Public Input Binder

The general purpose of proposed "**Colwood Land Use Bylaw No. 151, 1989, Amendment No. 206 (CD40 – 2324 Sooke Rd), Bylaw No. 2003, 2023**" is to amend the current Colwood Land Use Bylaw No 151, 1989 to enable the development of a six-storey residential apartment building consisting of 67 units.

City of Colwood STAFF REPORT

To: Planning and Land Use Committee
Date: May 1, 2023
From: Desiree Givens, Planner II
RE: Rezoning Application RZ-22-016 for 2324 Sooke Road

Table 2: Criteria for Mid-Rise Apartment

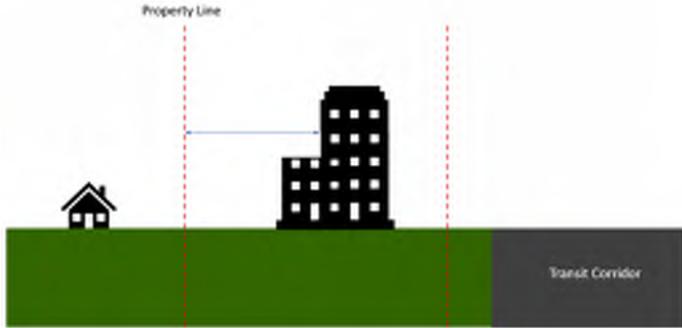
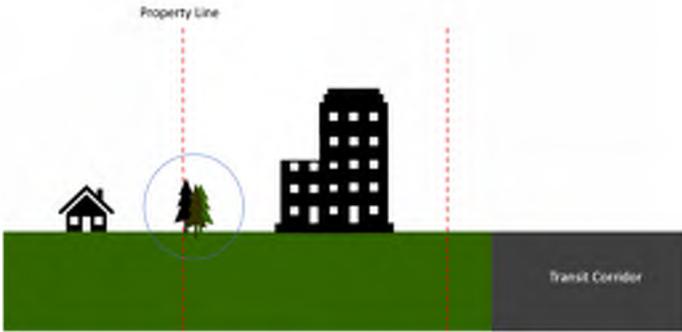
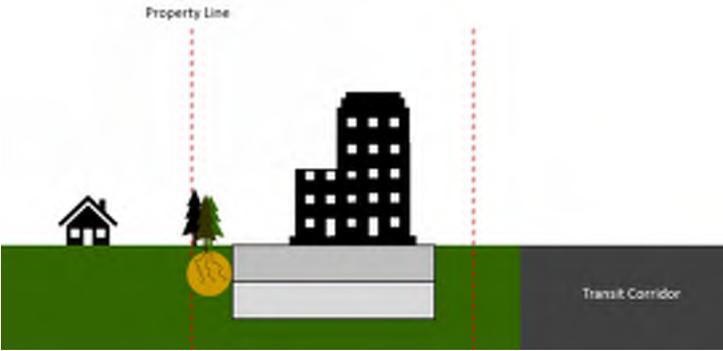
Criterion	Rationale (why this is important)
<p>The fourth storey (and above) requires a greater setback to property lines adjacent to single family homes or duplexes.</p>	<p>This criterion encourages development proposals to incorporate a transition in scale to existing single-family residential neighbourhoods (as shown in the image below) in which the proposed mid-rise building “steps down” in height/scale when located next to existing predominantly single family/duplex neighbourhoods that are designated by the OCP as controlled growth areas.</p> 
<p>A landscape buffer must be provided along the inside of all property lines next to a property that is zoned for residential uses. This buffer must be no less than 2 metres (roughly 6.5 feet) in height and no less than 1.5 metres (roughly 5 feet) in width.</p>	<p>This criterion helps protect the privacy of neighbouring residential properties by requiring a landscape screen at the property line.</p>

<p>An underground parkade structure must not be built to property line. Instead, parkade structures must be set back at least 3 metres from any property line.</p>	<p>This criterion was established with the intention of supporting the feasibility of planting landscaping along the property’s perimeter.</p>

Criterion	Rationale (why this is important)
A minimum lot width of 60 metres and a minimum lot area of 4,000 m ² is required to support a mid-rise apartment use.	<p>The criteria for minimum lot width and area were based on the desire to see lot consolidation along transit growth corridors throughout Colwood and thus more proactively plan for development that could achieve the City’s desire to provide a gentle transition in scale down to predominantly single-family residential neighbourhoods. Further, the intent was also to minimize the number of accesses off transit growth and arterial roads such as Sooke Road.</p> <p>Various lot sizes and widths were tested by the architectural firm that peer reviewed the TGA1 zone to determine that a width of 60 metres and an area of 4,000 m² is roughly the smallest combination that could reasonably support a 6-storey building with a FAR of 2.5 while still meeting the criteria described above to sensitively integrate into surrounding single-family residential (e.g., ensuring that the built form would make sense given the requirement for the upper 3 storeys to be stepped in further where next to predominantly single family residential).</p>

P1 PARKING PLAN

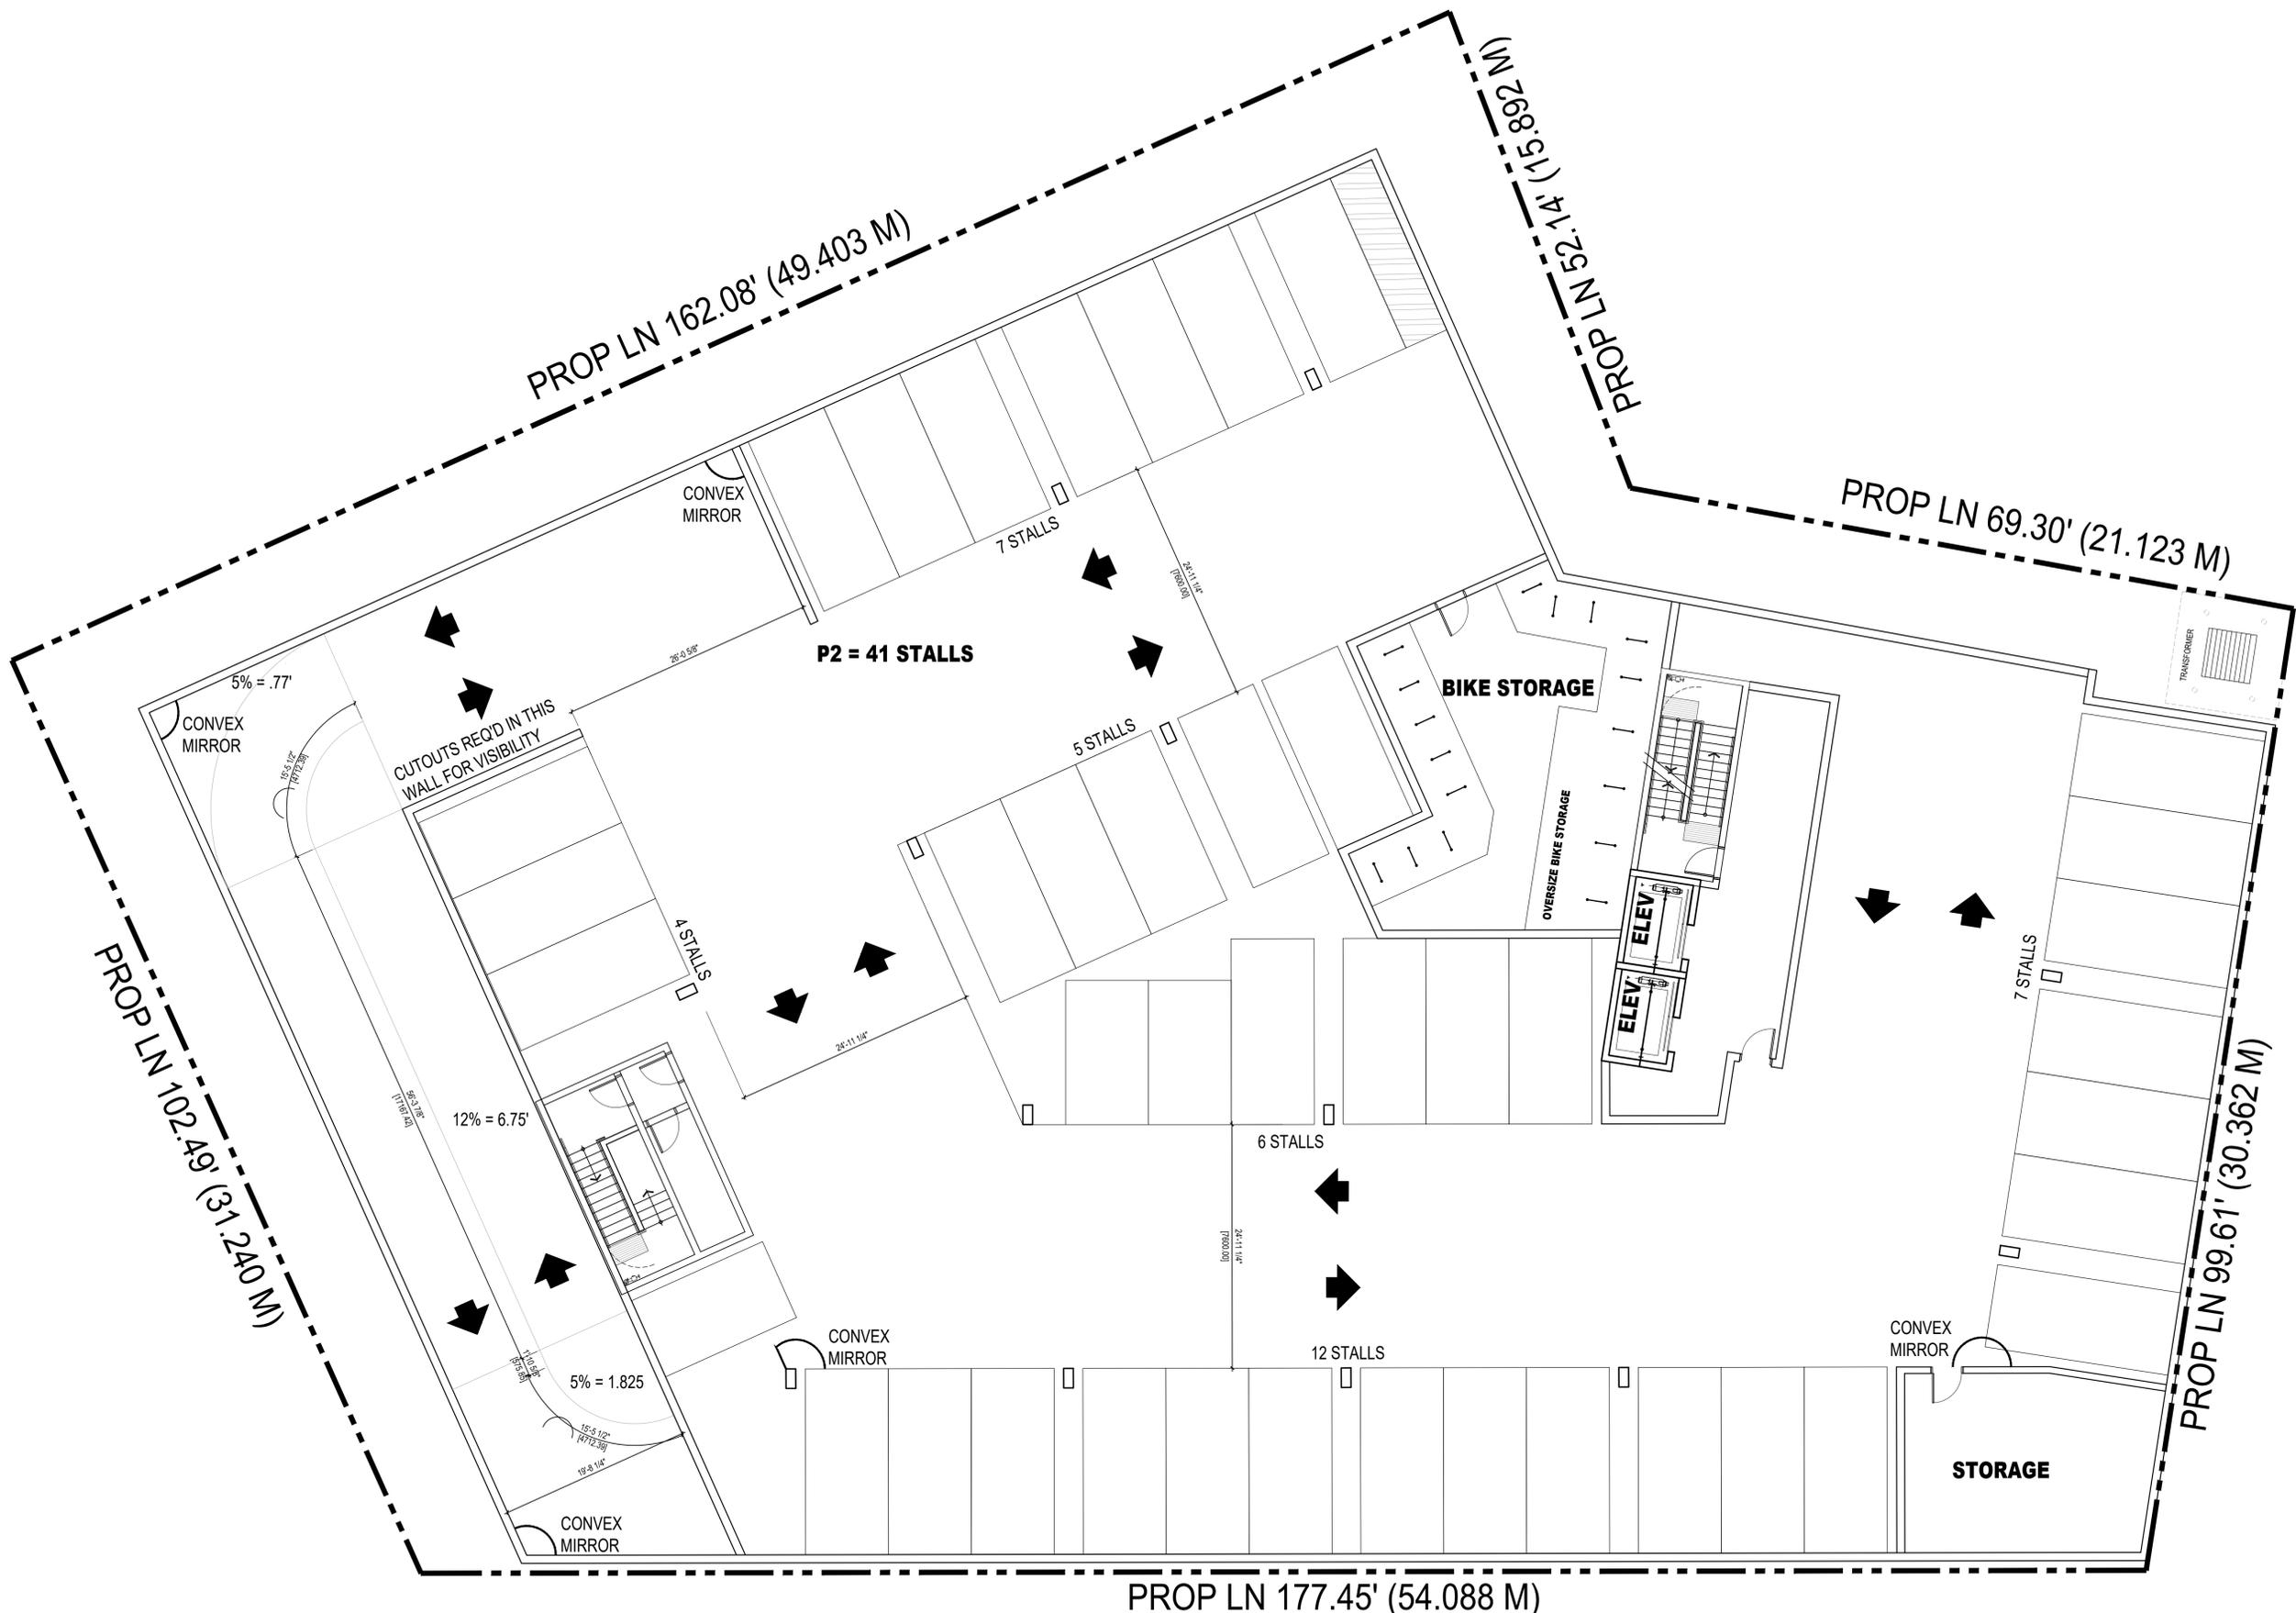
The configuration of the parking garage ramp relative to the adjacent parking aisles is awkward and has some challenges as it pertains to sightlines and circulation of vehicle traffic at the top and bottom of the ramps. It is acknowledged that the site is irregularly shaped, providing a challenging environment for ideal circulation. The site plan includes cutouts in the ramp walls to provide additional visibility, as well as convex mirrors at all 90 degree turns in the garage to mitigate these conditions.

- Provide cutouts in the parking garage ramp walls and convex mirrors at all 90 degree turns to provide additional visibility within the parking garage.
- Install sidewalks along the Lynnlark Place and Sooke Road frontages.

Staff PowerPoint

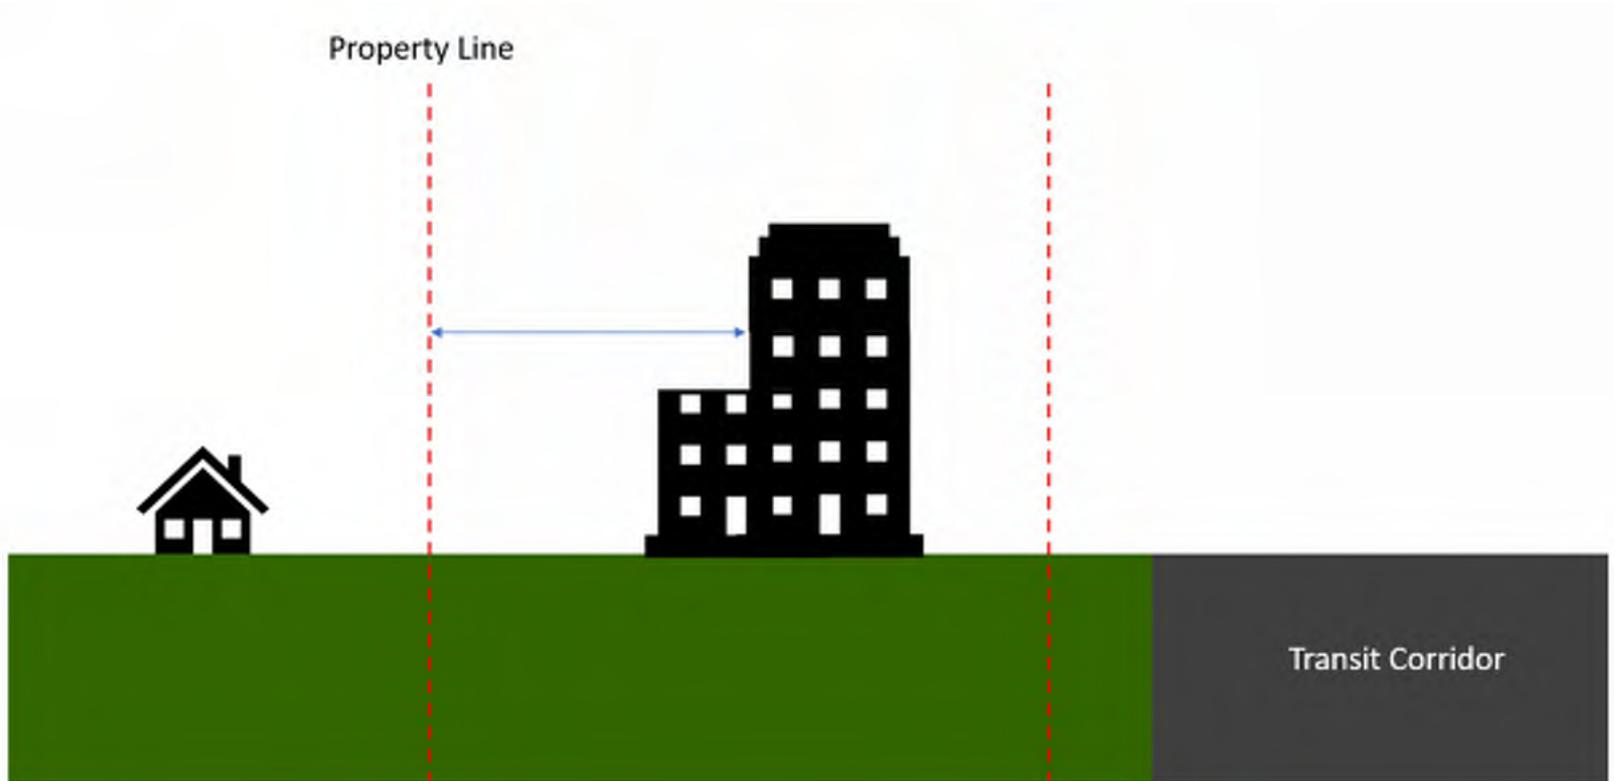
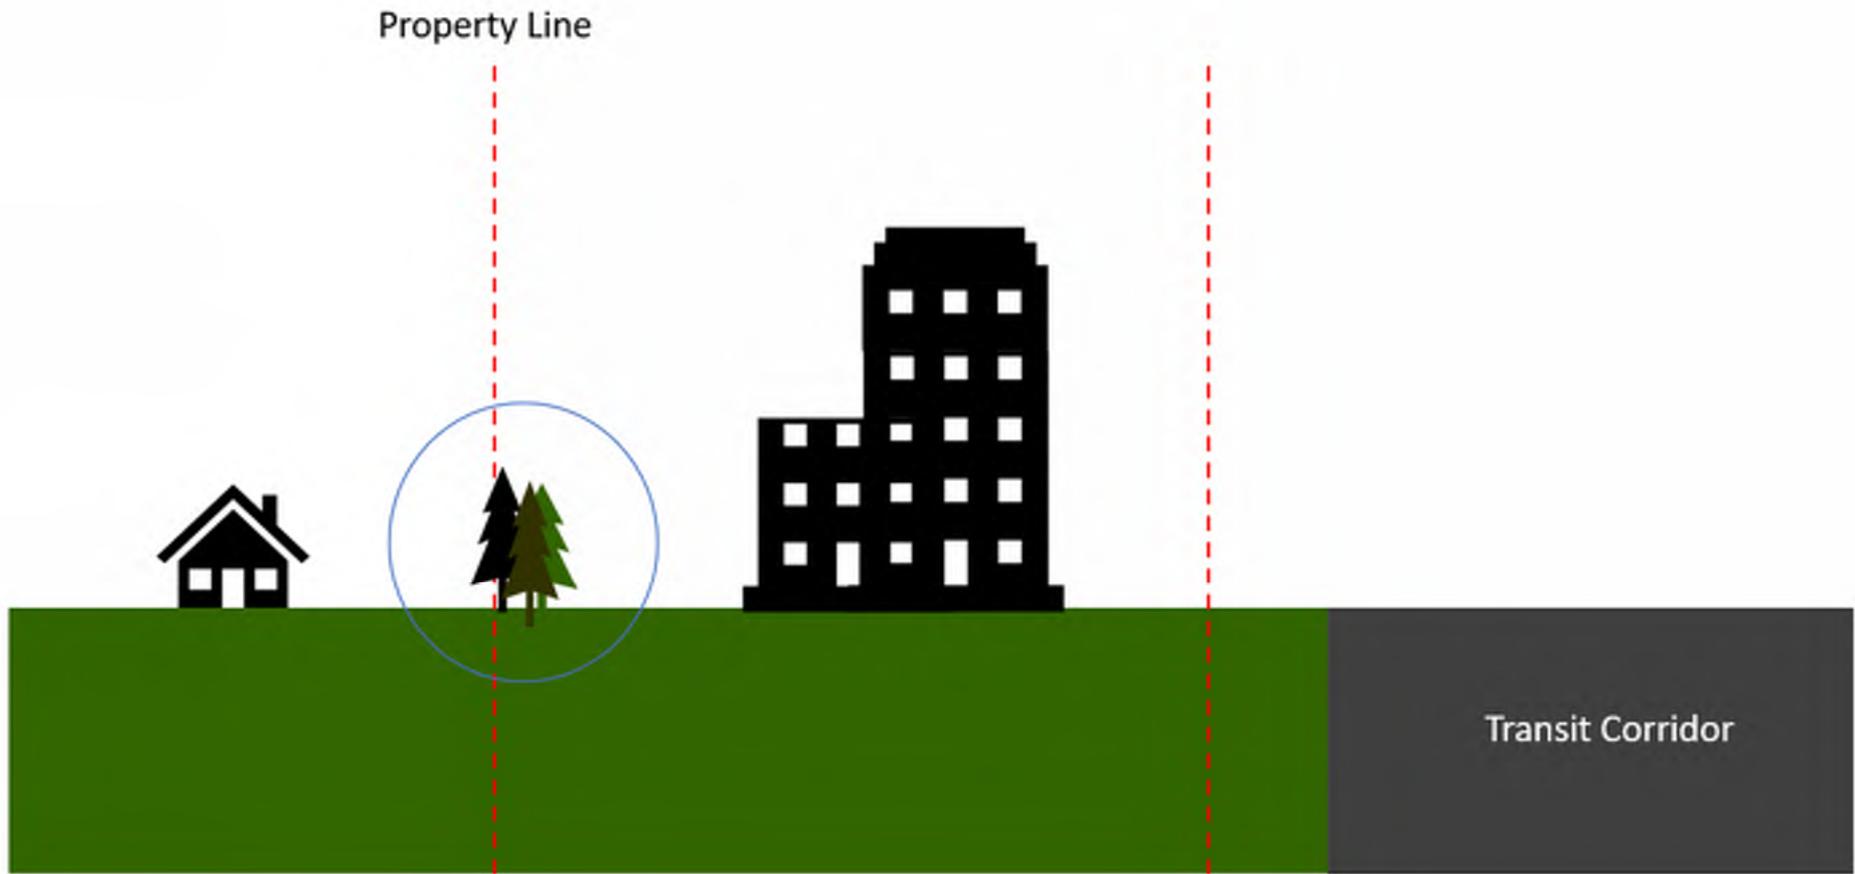
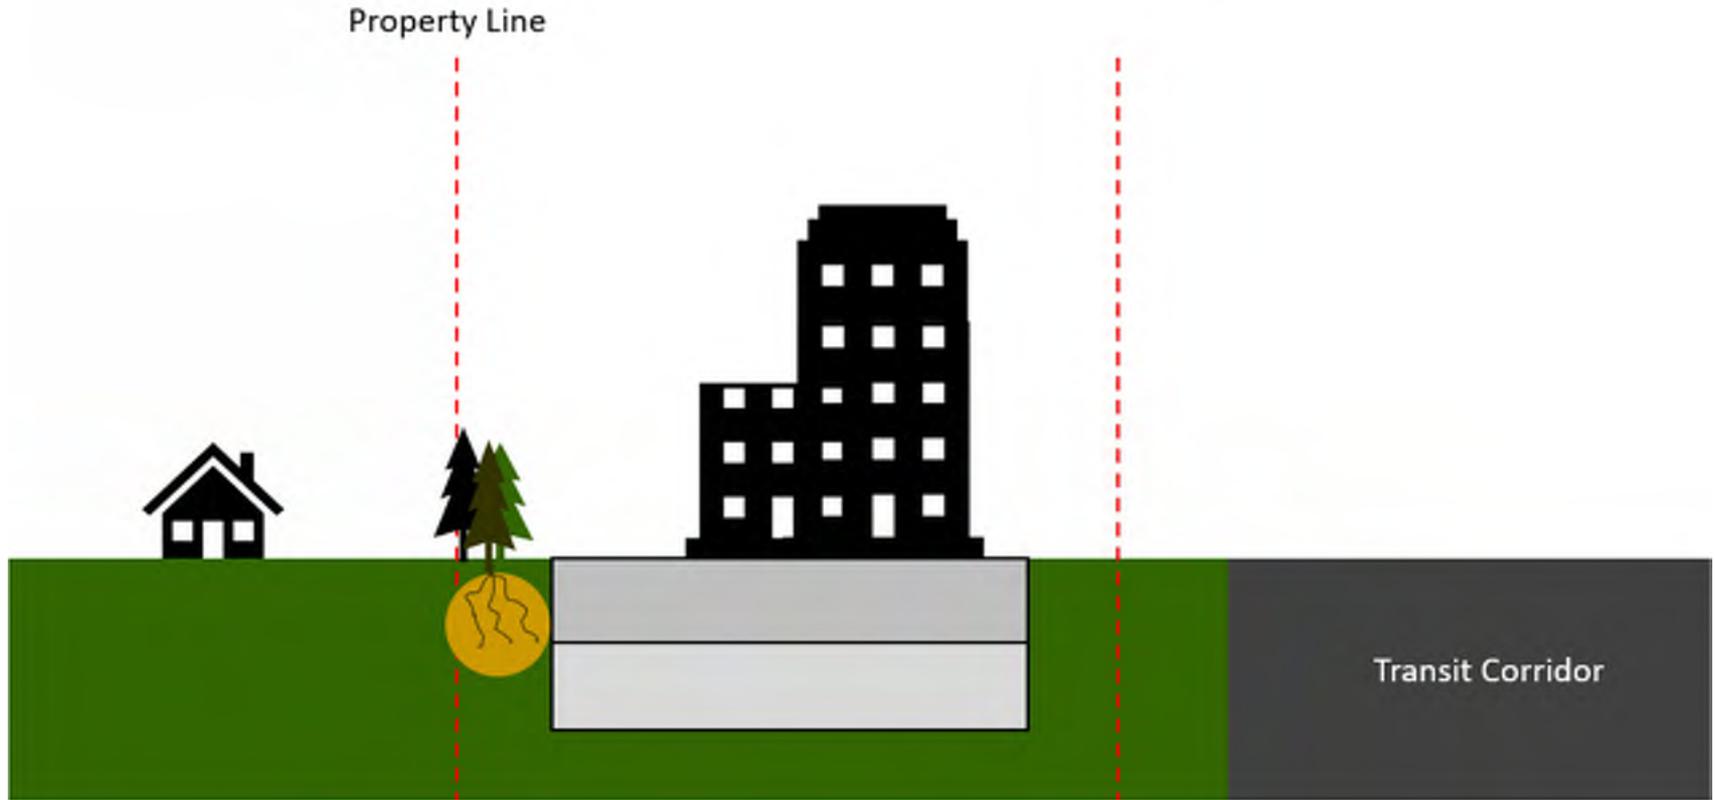
City of Colwood STAFF REPORT
